# PLAN COMMISSION STAFF REPORT

**Agenda Item:** PC 24-012

**Application Type:** Development Plan

**Summary:** Tony Gierczyk with E. Anthony Inc., for ONSI (Orthopedic Specialists of Northwest Indiana) is requesting a Development Plan approval for the exterior renovation of a 10,000 SF church building into a medical office facility, including site improvements to the parking lot, landscaping, and stormwater detention. The proposed Development Plan is a scale back of the a previously approved Development Plan at 9900 Columbia Avenue. PC 23-029 - January 09, 2023).

Sheet Name  
**SITE LIGHTING SITE PLAN**  
 Sheet Number  
**ES101**  
 © 2024 Ridgeland Associates, Inc.

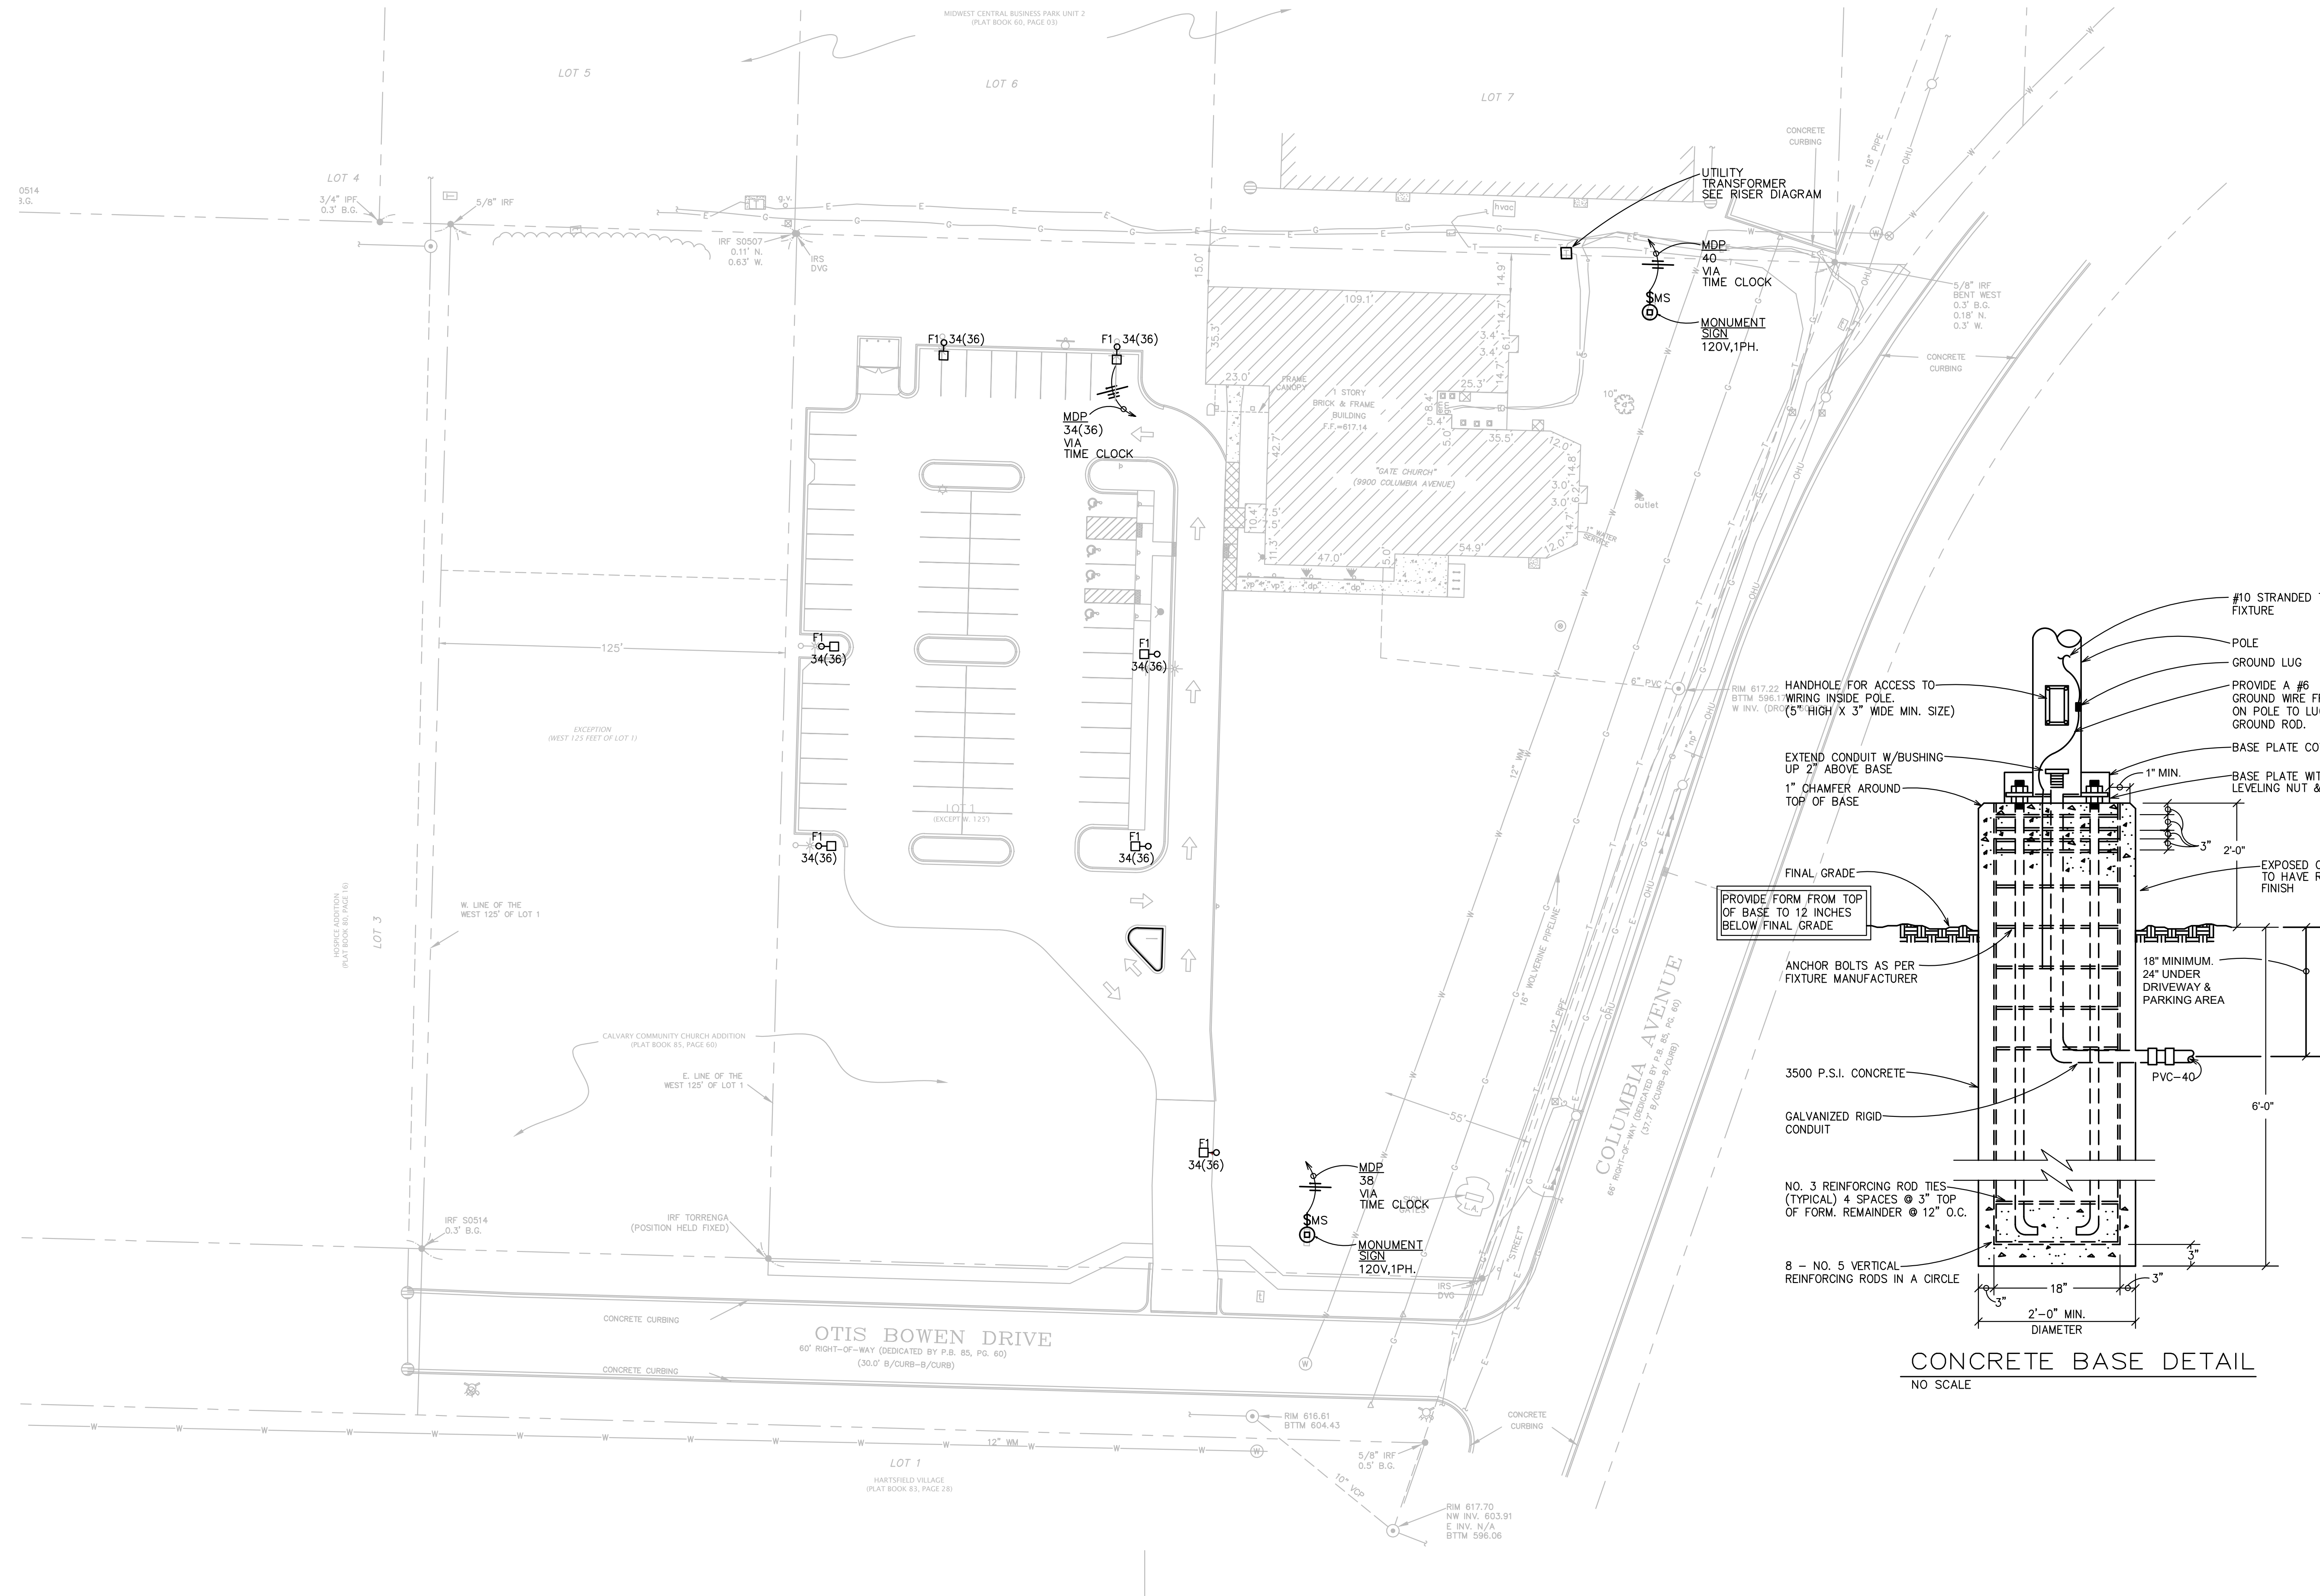
In review of the Development Plan Application and supporting documents staff is requesting additional information regarding the lighting plan to include pole detail and head type. As well as proposed sign package. The applicant has submitted additional information regarding site lighting plan and monument signage.

3 MONUMENT SIGN 2 1/2" = 1'-0"

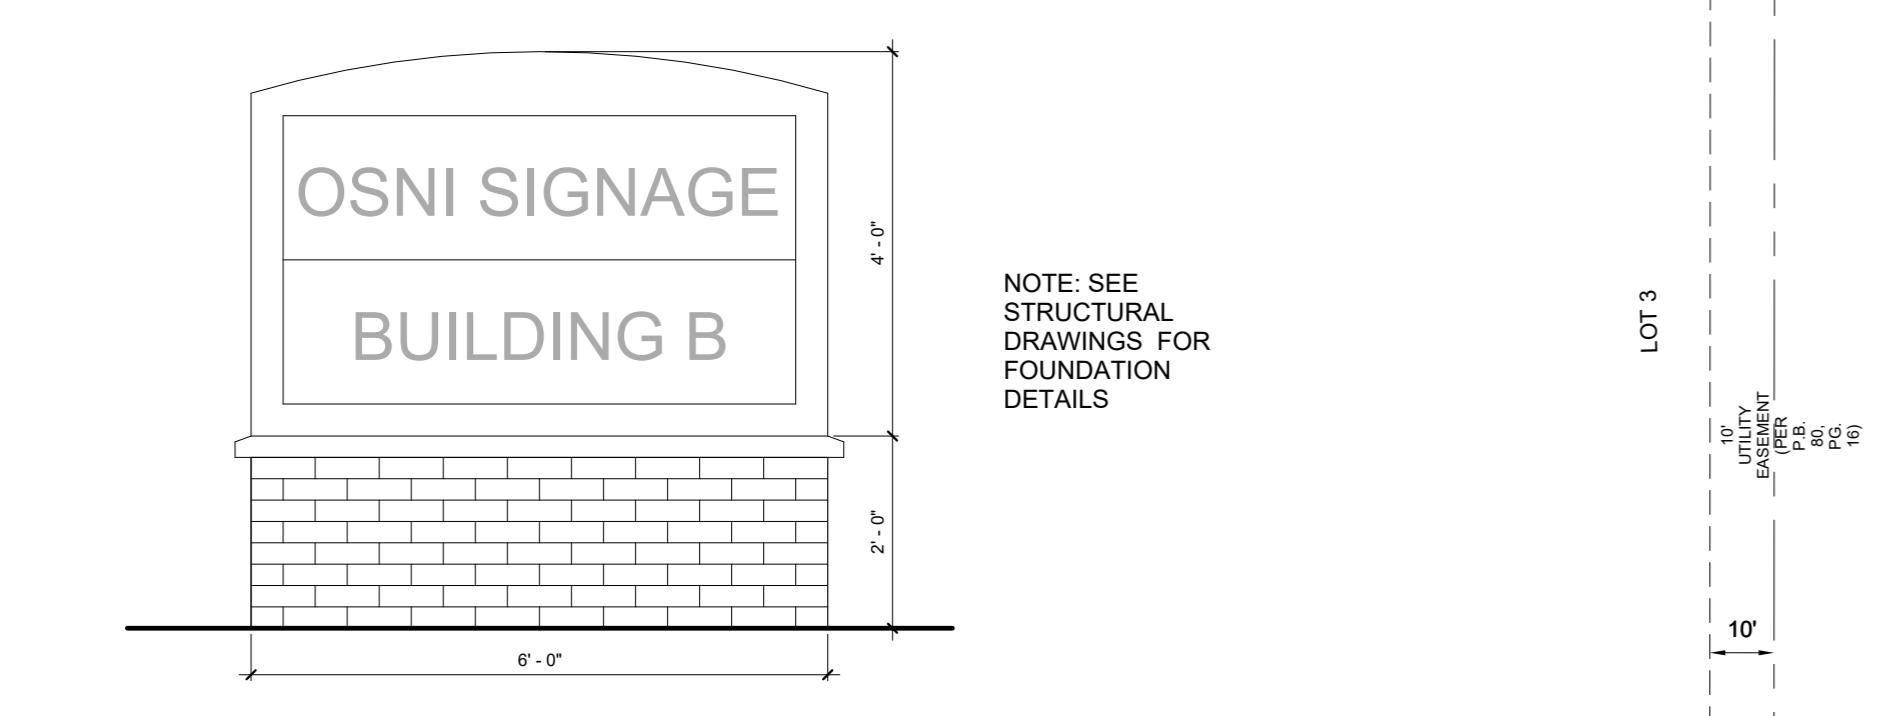
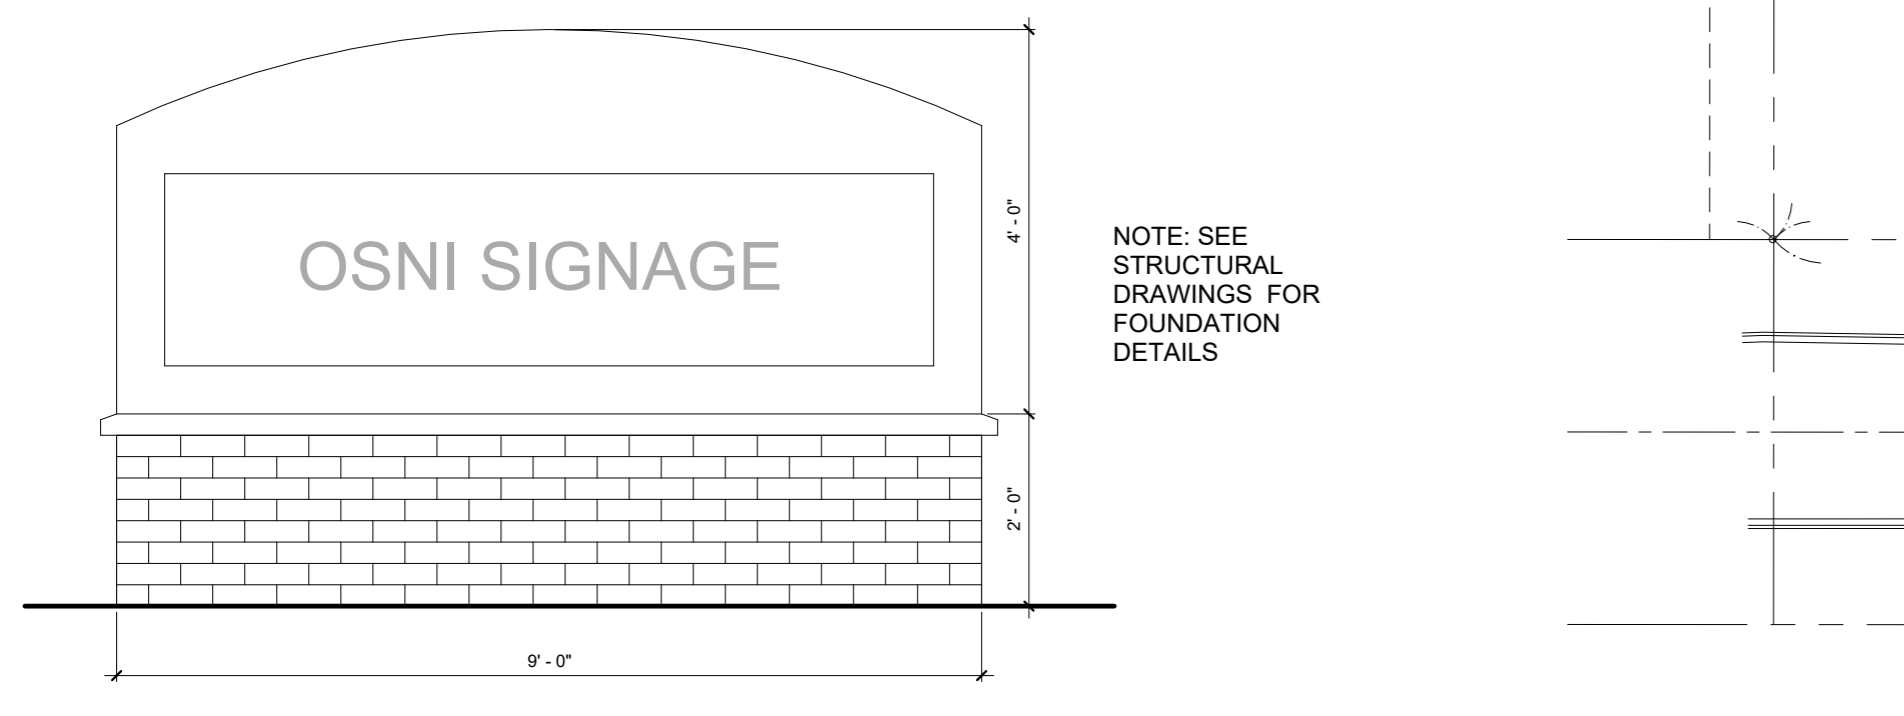
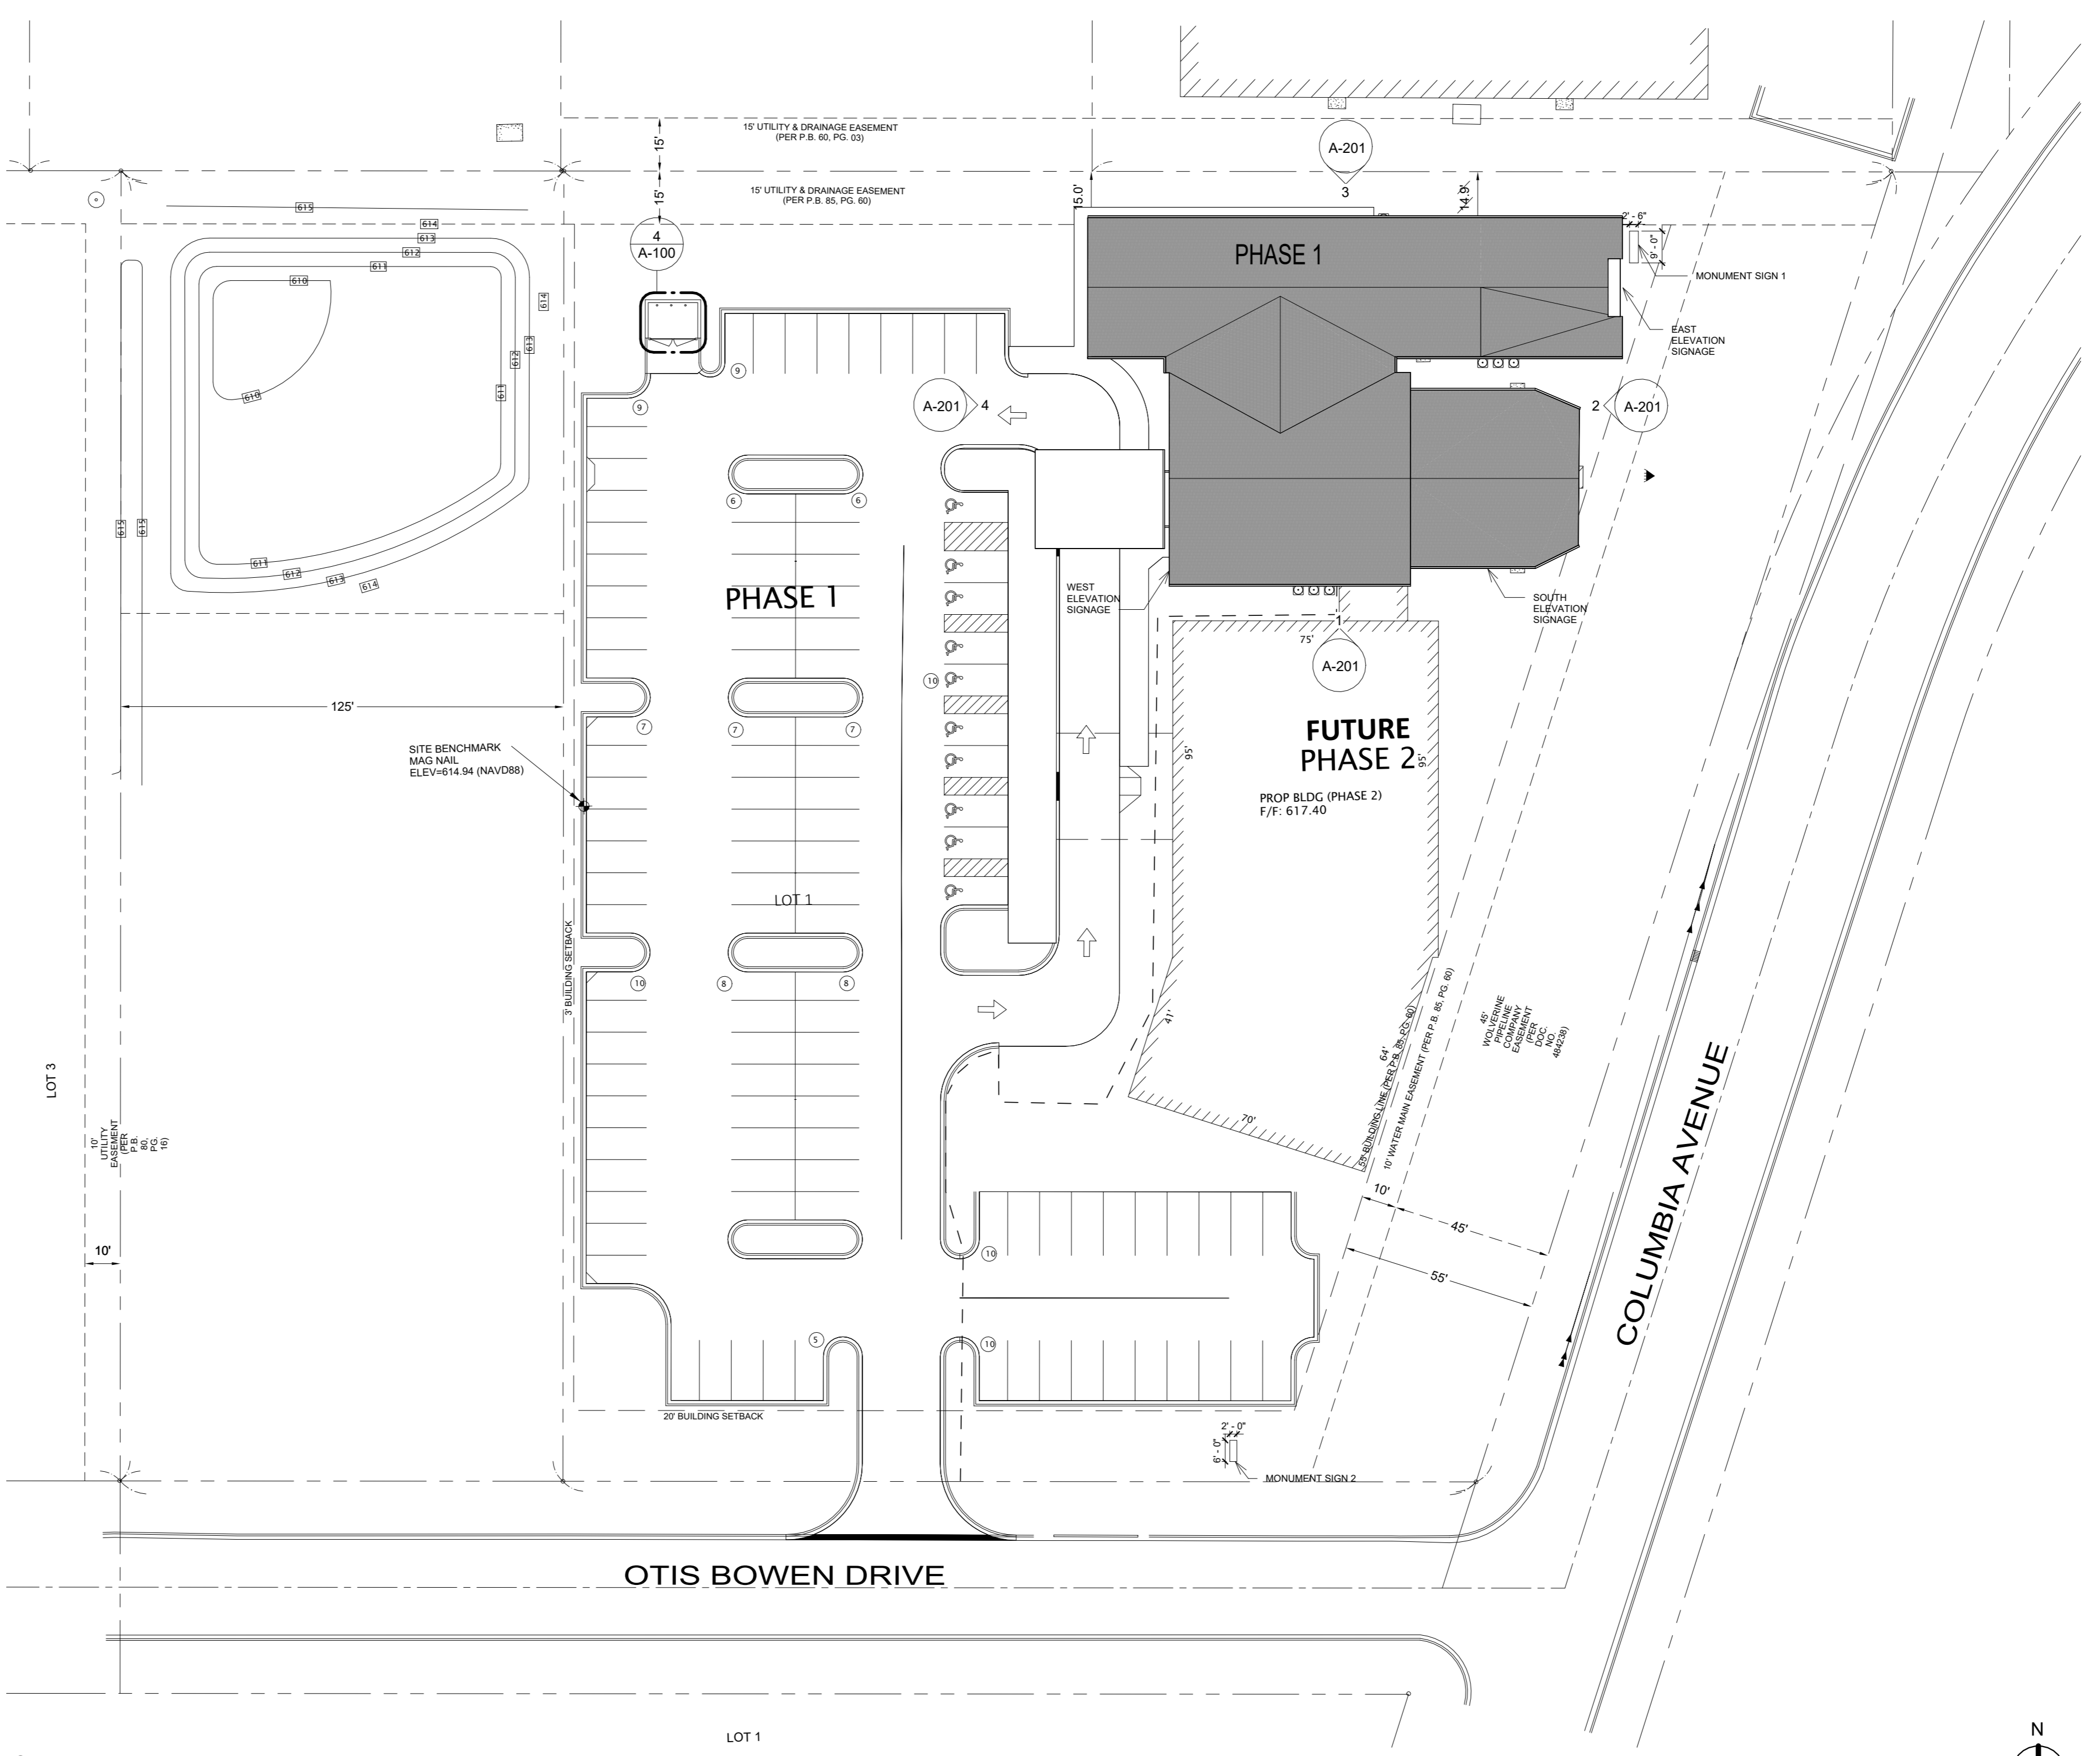
Staff is unclear if the monument sign plan is current because the plans identify an expanded parking lot and future phase 2 of a building. The applicant should provide clarification on the monument plan submitted, one or two monument signs. The monument sign specs submitted appear to meet the zoning standards of 6' H max and 18 SF sign area. Sign material has not been identified and may require a Developmental Standards Variance upon review of a submitted sign permit application.
